STAFF RECOMMENDATION
1813 Blair Boulevard
June 18, 2014

Application: New construction—duplex infill and outbuildings; Setback determination.
District: Belmont-Hillsboro Neighborhood Conservation Zoning Overlay
Council District: 18
Map and Parcel Number: 10416006700
Applicant: Keith Dowd
Project Lead: Melissa Baldock, melissa.baldock@nashville.gov

GARAGE PLANS

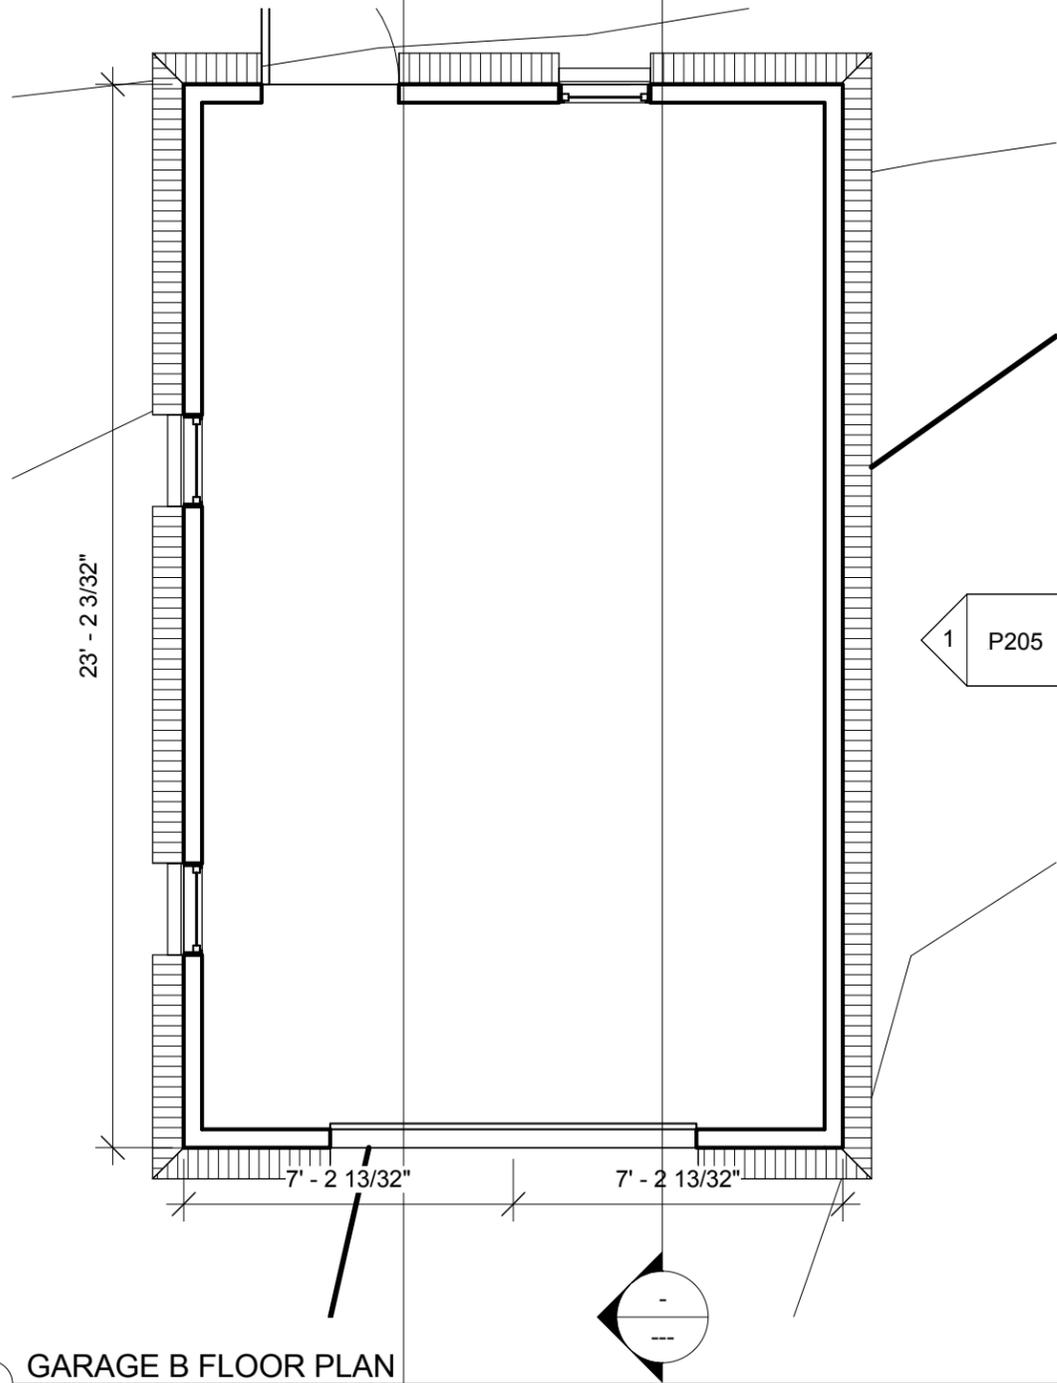
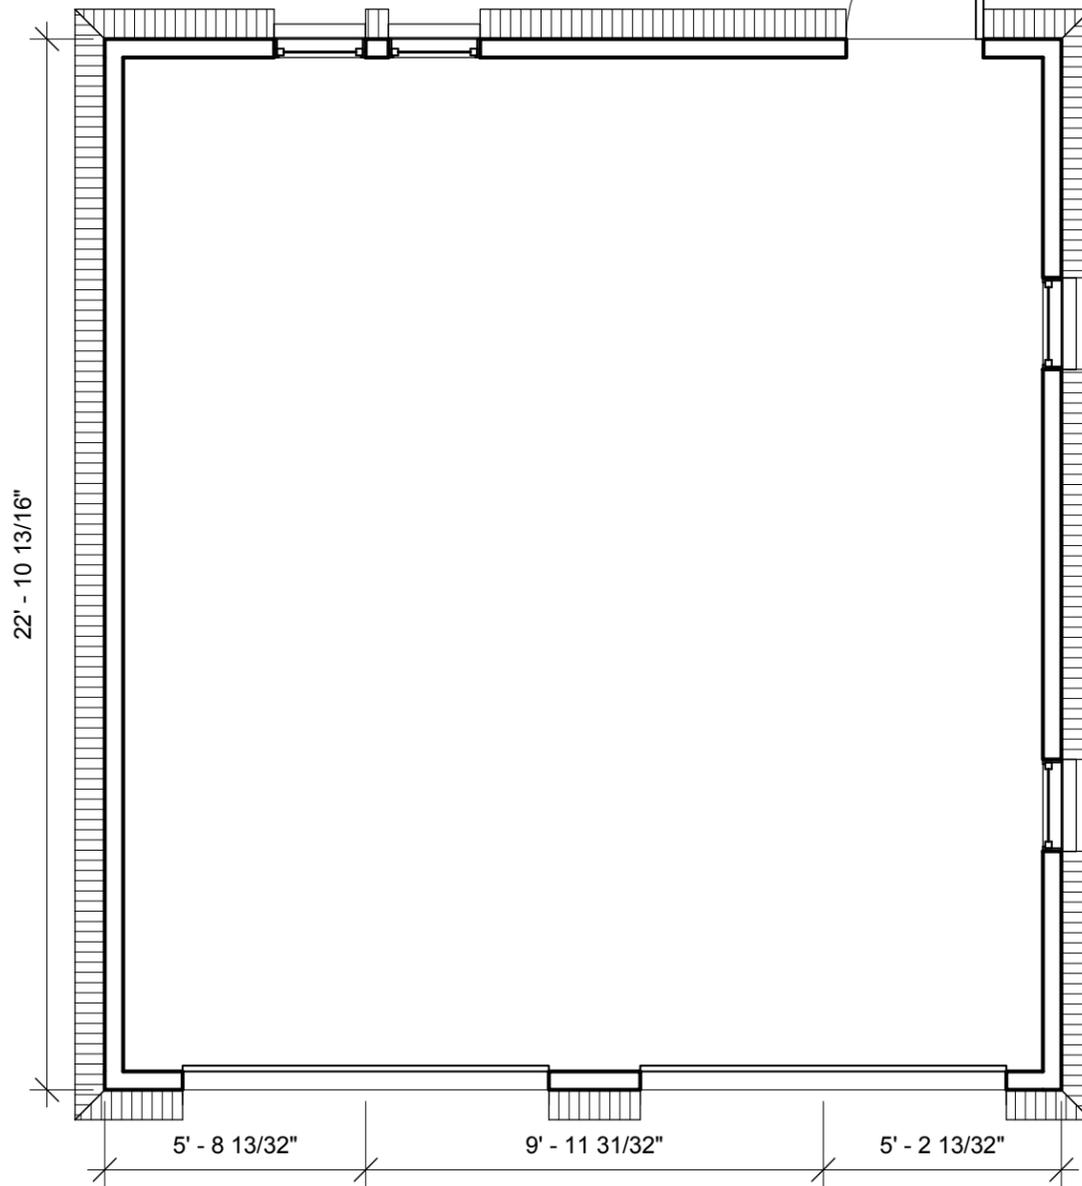
Outbuildings: The applicant is proposing two outbuildings, both of which will be one story in height. One outbuilding will be a one-car garage that is fourteen feet, six inches (14'6") wide by twenty-three feet, two inches (23'2") deep, or three hundred and thirty-six square feet (336 sq. ft.). The other outbuilding will be a two-car garage that is twenty-one feet (21') wide by twenty-two feet, eleven inches (22'11") deep, or four hundred and eighty-one square feet (481 sq. ft.). In total, the outbuildings have footprints that are eight hundred and seventeen square feet (817 sq. ft.). Staff finds that garages' footprints meet the design guidelines. The outbuildings will have eave heights ranging from seven to ten feet (7' – 10') due to the grade. The ridge heights will be between fourteen and seventeen feet (14' - 17').

The garages will be accessed via the alley, which is appropriate. The garages do require a setback determination for the rear. Base zoning requires that two outbuildings with a combined square footage of more than seven hundred square feet (700 sq. ft.) be located

twenty feet (20') from the rear property line. The applicant is proposing to locate the garages approximately ten feet (10') from the rear property line. Staff finds the proposed location of the outbuildings to be appropriate since historically, outbuildings were located ten feet (10') or less from the rear property line. The materials for the outbuildings are brick and cement fiberboard panel with an asphalt shingle roof. The roof form will be hipped with a slope of 6/12.

Staff finds that the proposed outbuildings meet Section II.B.1.i of the design guidelines.

1 EAST ELEVATION PROPOSAL
 1/8" = 1'-0"

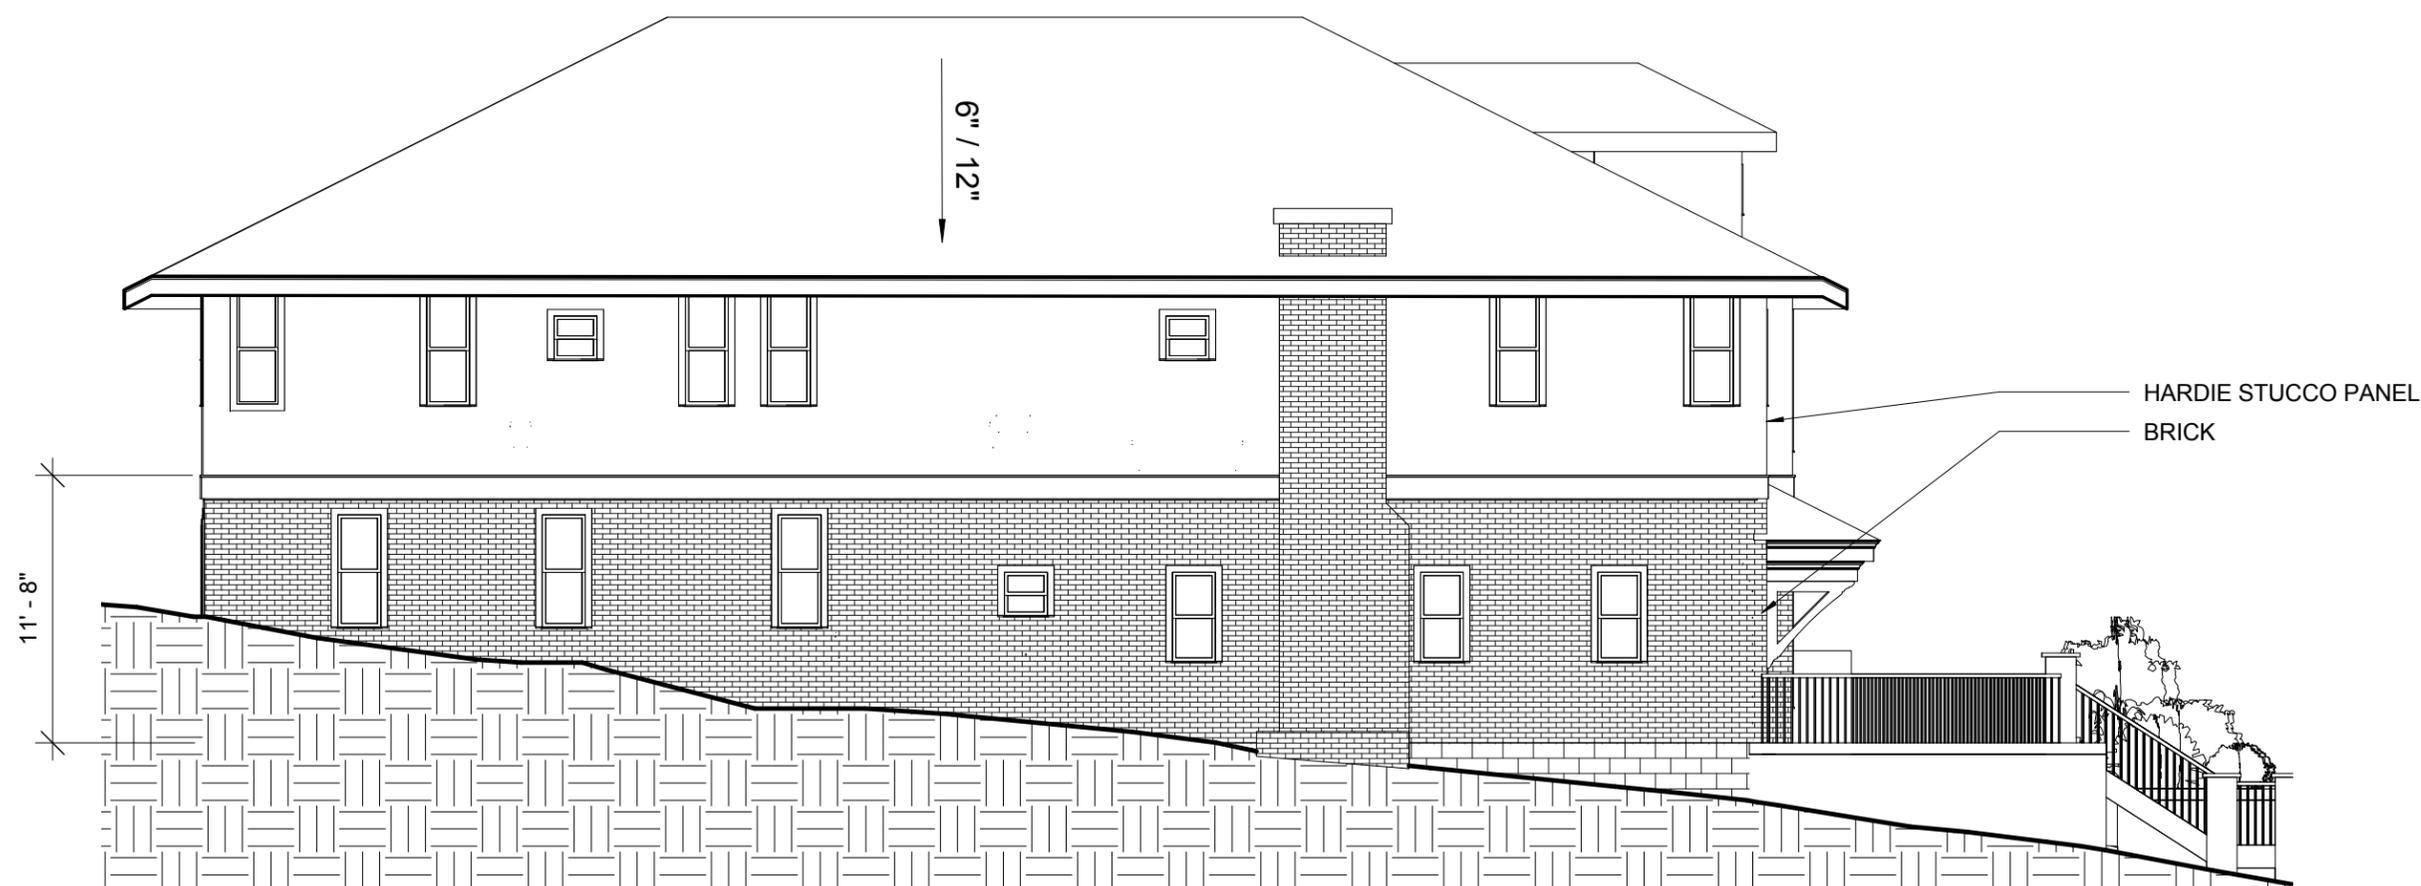
Proportion and Rhythm of Openings: The window openings on the front façade are generally at least twice as tall as they are wide and meet the historic proportion of window openings. Staff notes that a larger window opening is needed in the front dormer. Historically, windows in dormers covered most of the front of the dormer, and the proposed dormer's windows are too small. On the side façade, the window pattern generally follows the typical rhythm of openings for historic structures. With the enlargement of the front dormer windows, staff finds that the project's proportion and rhythm of openings meet Section II.B.1.g. of the design guidelines.

1. Staff review and approve a brick sample, all window and door specifications, and the asphalt shingle color;
2. Staff review and approve the materials for the foundation, porch/terrace floor, and the railings;
3. The windows on the front dormer be enlarged; and
4. The HVAC units be placed at the rear of the duplex, or on a side façade, beyond the midpoint of the house.
